## **ADDENDUM NO. 1**

Date:	June 4, 2018	Owner:	ITD
Project:	Coeur d'Alene Equipment Shed Reroof		
Project No.:	18-100	No. of Pages	3

## EXTENDED EAVE OVER DECKING

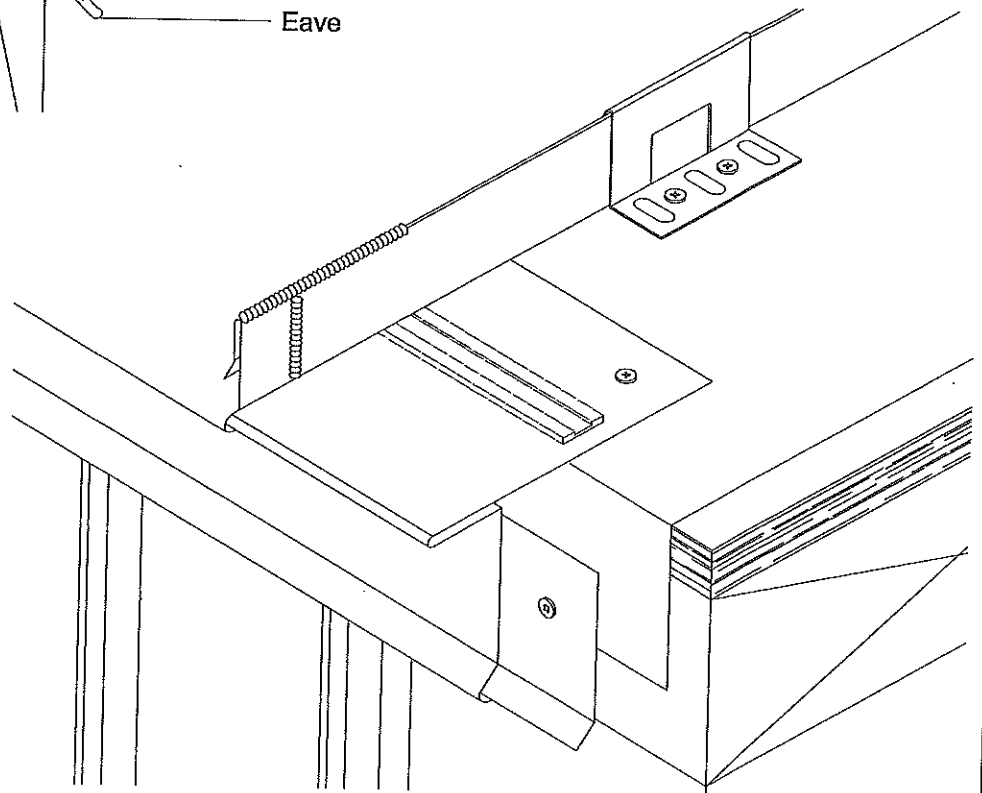
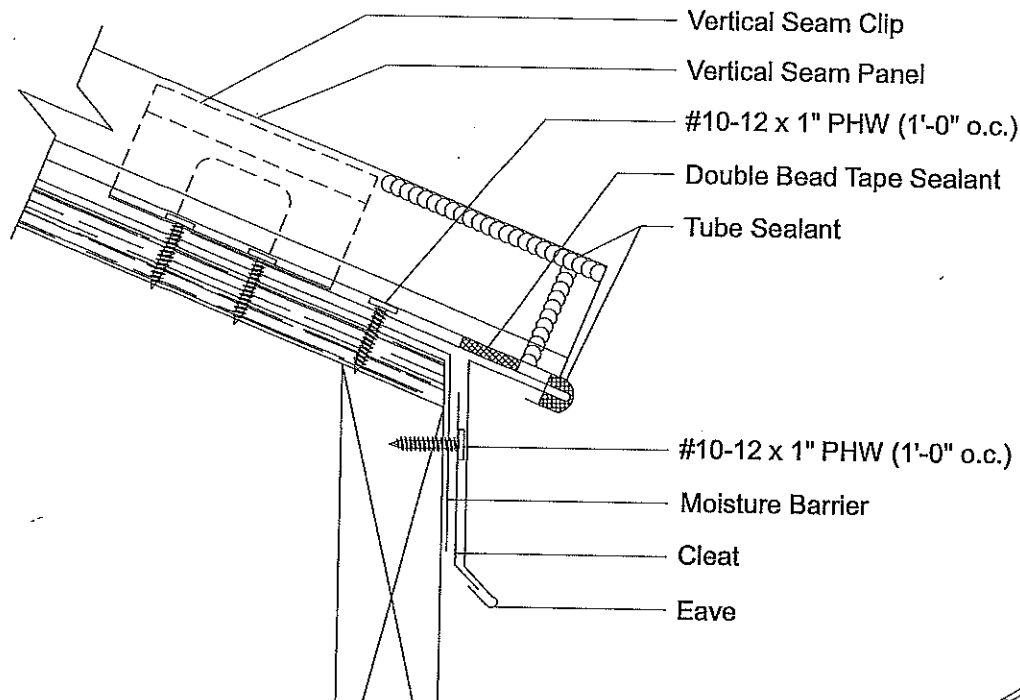
RESPONSE: Base bid for 26 GA metal panel to be standard mfg. paint coating. Alternate bid for 24 GA standing seam roof to be Kynar coated.
5. QUESTION:(Detail for Alternate) - Do you want the standing seam panel hemmed and locked into a drip edge or cleat? or do you want it overhung and fastened through the panel?

RESPONSE: Standing Seam Roof shall be locked in. See attached standing seam drip edge detail.
6. QUESTION: Will ITD pay for building permits.  
RESPONSE: Yes, ITD will pay for building permits. Contractor is responsible for trade permits.

**Note:**  
Panel rib must be  
field notched and flat  
part of panel must be  
field bent to accept  
Extended Eave  
(see page 18).

**All Eave flashings must be installed prior to panel installation.**

1. Position and install Cleat to wall with appropriate fastener, 1'-0" o.c. Make sure Cleat allows for proper Extended Eave attachment.
2. Install Extended Eave flashing by sliding open hem onto Cleat and resting Extended Eave Flashing back against substrate. Fasten to substrate with #10-12 x 1" Pancake Head Woodscrew, 1'-0" o.c.
3. Apply a row of Double Bead of Tape Sealant to extended leg of the Extended Eave flashing.
4. Install panel by engaging field hemmed end of panel (see page 18) to Extended Eave (see pages 20-21 for panel installation).
5. If two or more flashings are required, lap the flashing over the previously installed flashing by a minimum of 2" placing a bead of Tube Sealant between the flashings and securing with pop rivets 2 1/2" o.c.
